**RE: Main Street Living, LLC
Proposed Mixed-Use Development
and Townhouse Development
Block 1, Lots 31, 33.01, & 34-36
7-9 Main Street &
11-13 Railroad Avenue
Township of Robbinsville
Mercer County, NJ
DEC # 5214-24-00441
Application #R25-03-01**

This letter shall serve as the formal response to the following Township of Robbinsville professional review letters and memorandums:

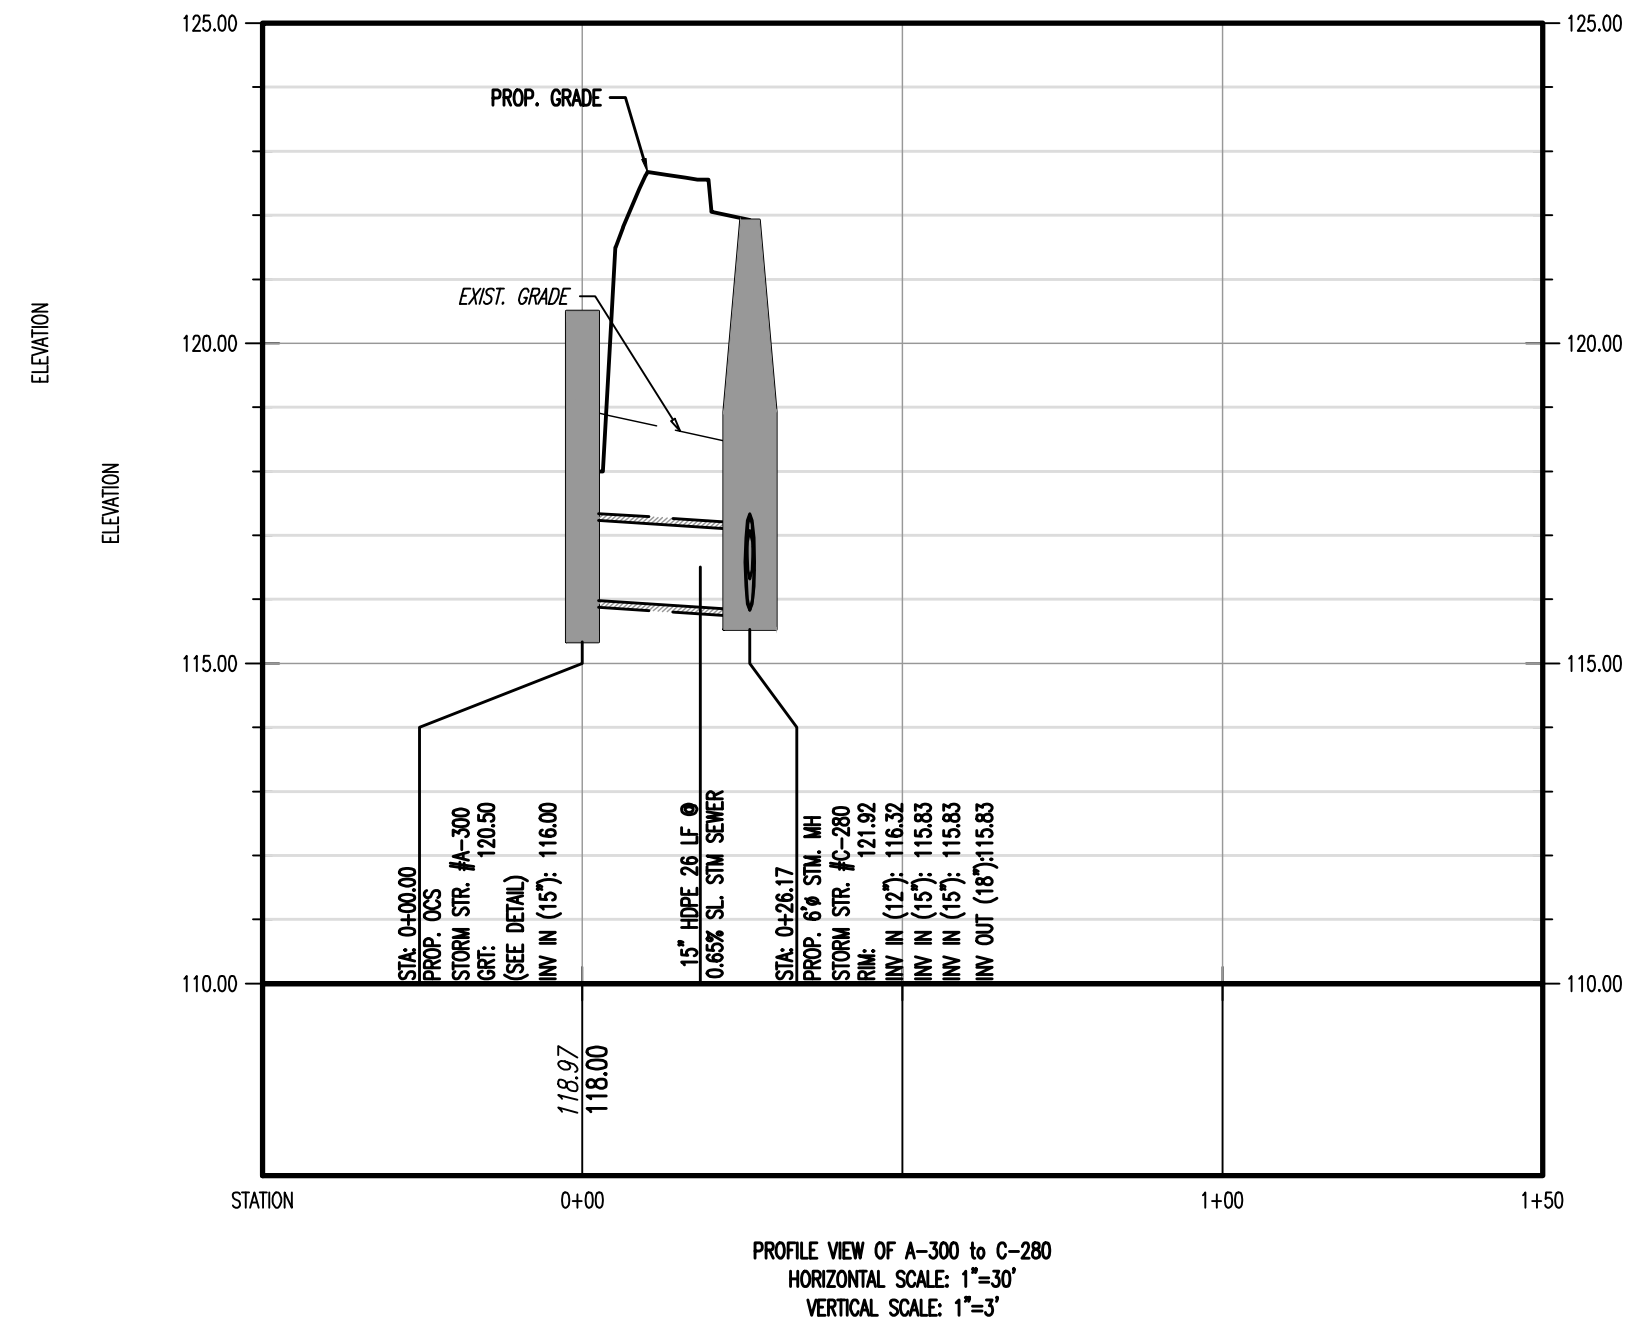
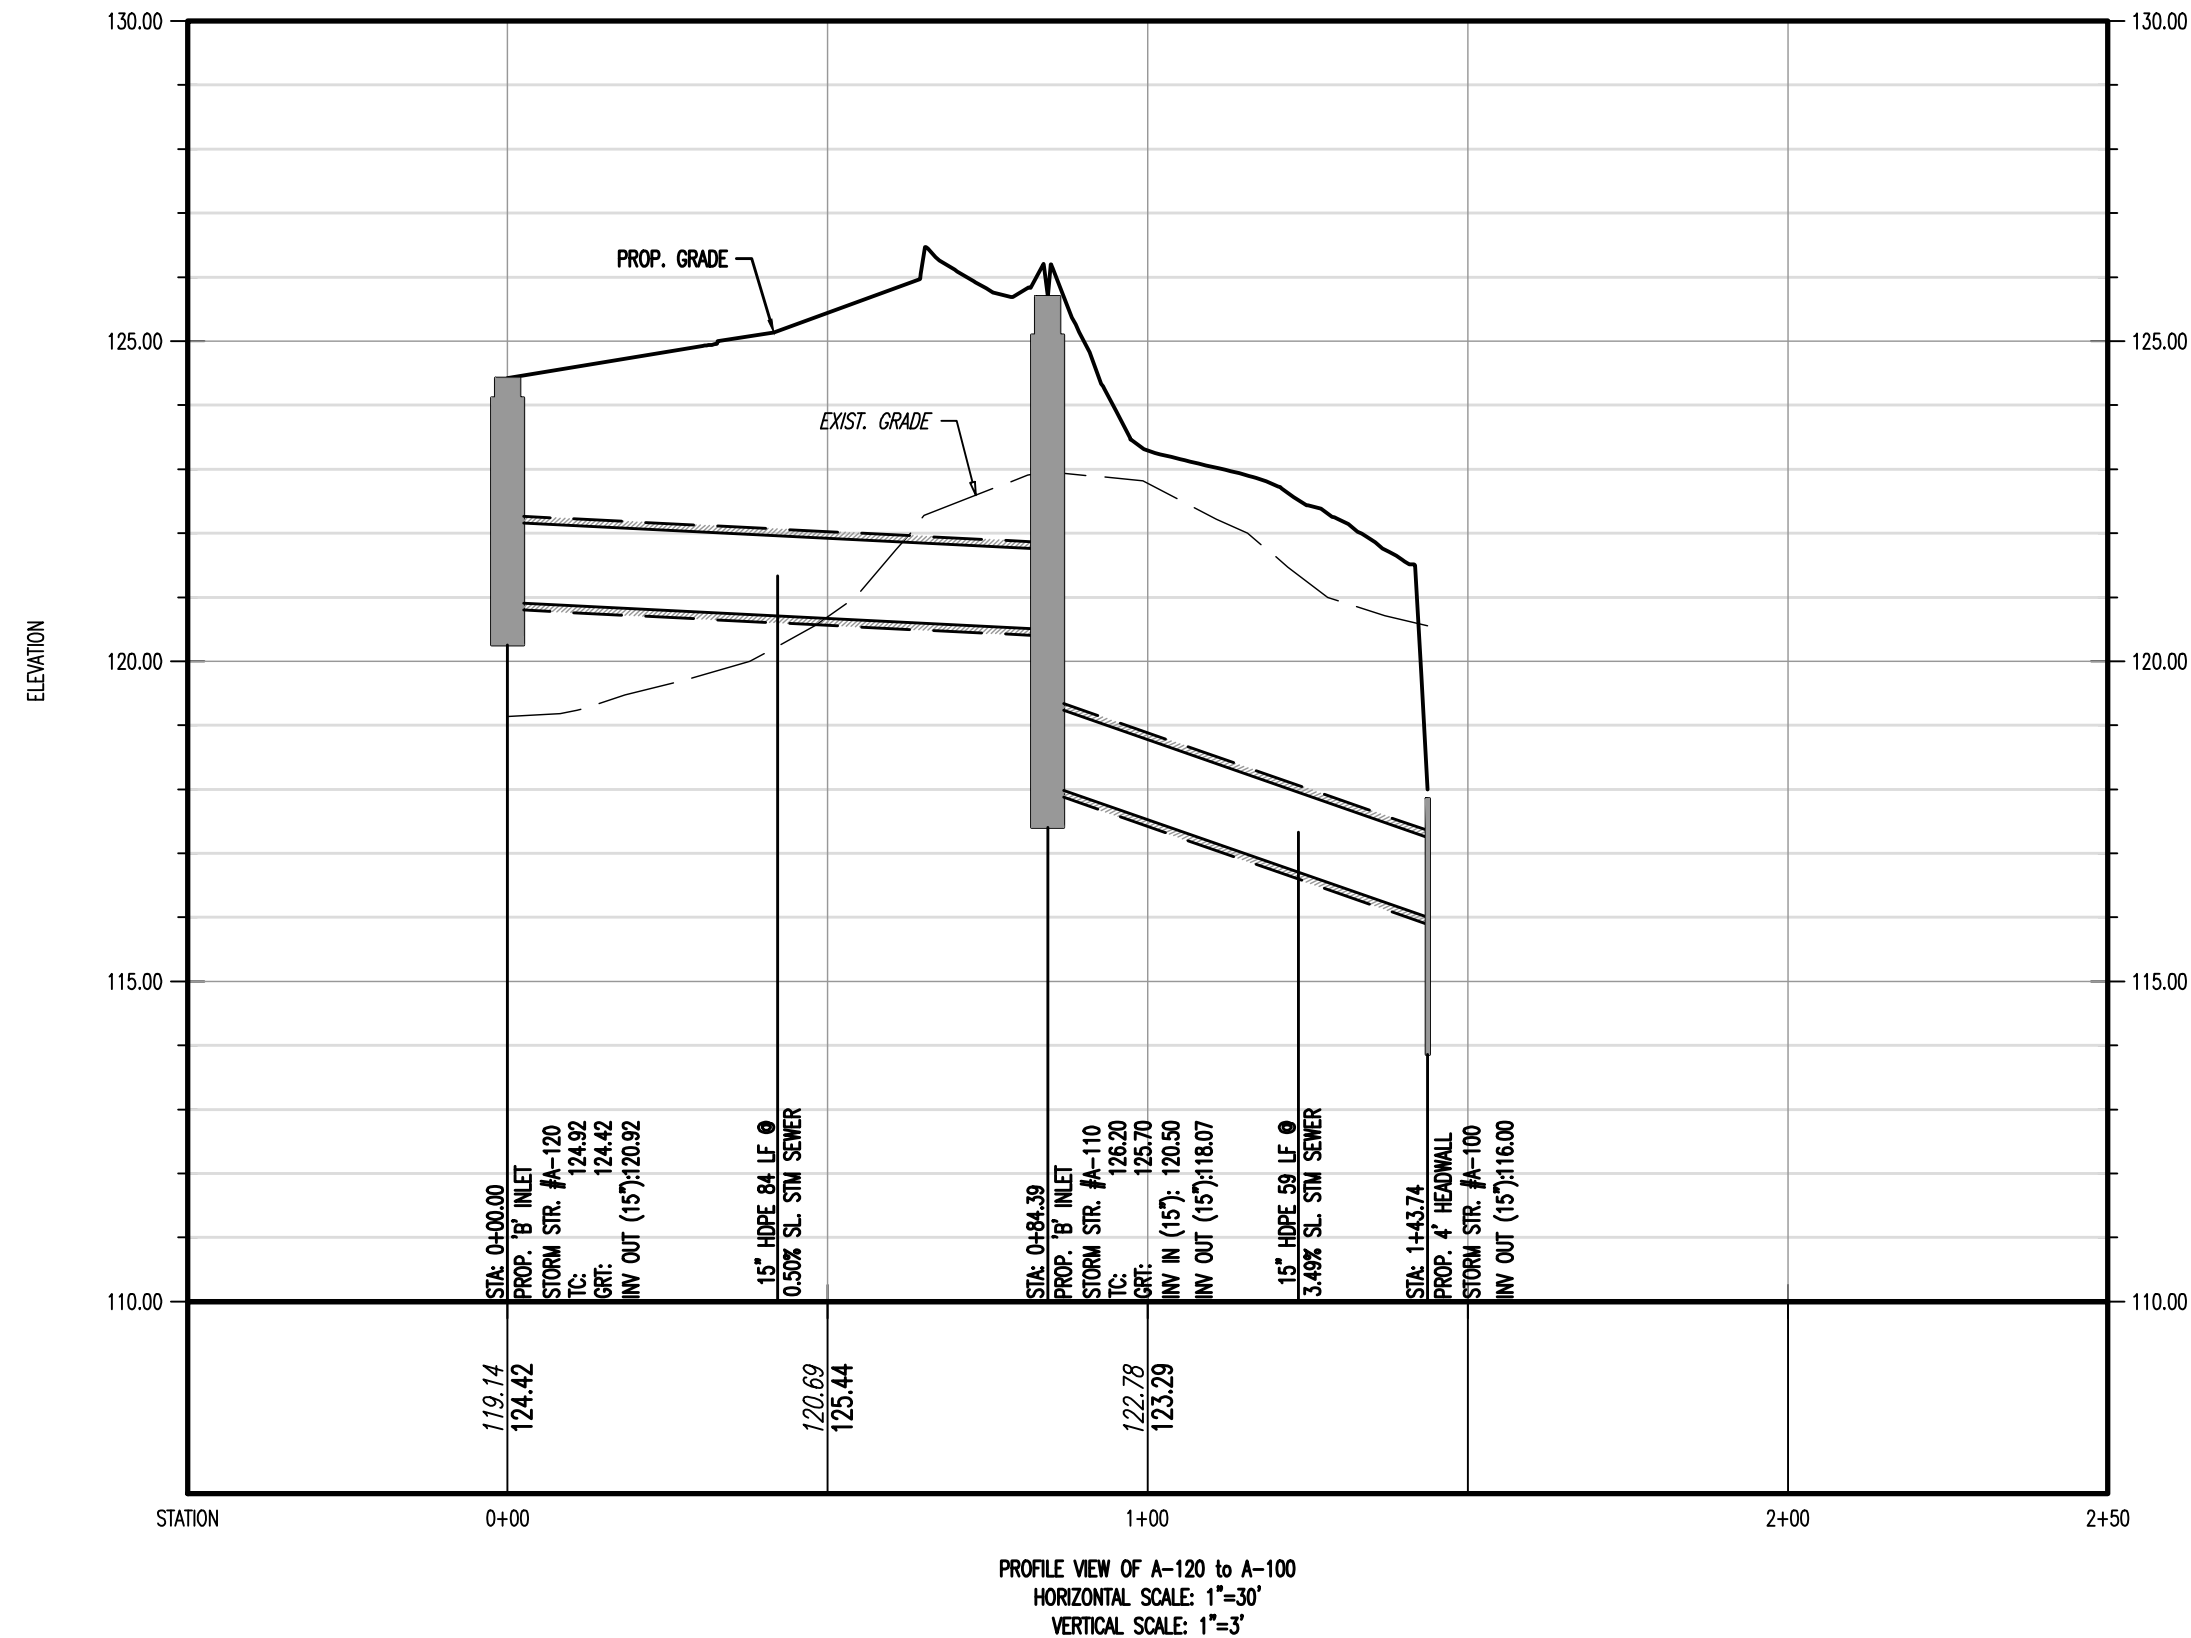
18. *Clarify the pipe crossings in the drainage profiles as it appears pipes are in direct conflict with each other. Revise text overlaps within the drainage profiles.*

The Drainage Profiles (Sheets 29-31 of 31) will be revised to remove text overlaps and pipe conflicts as a condition of approval.
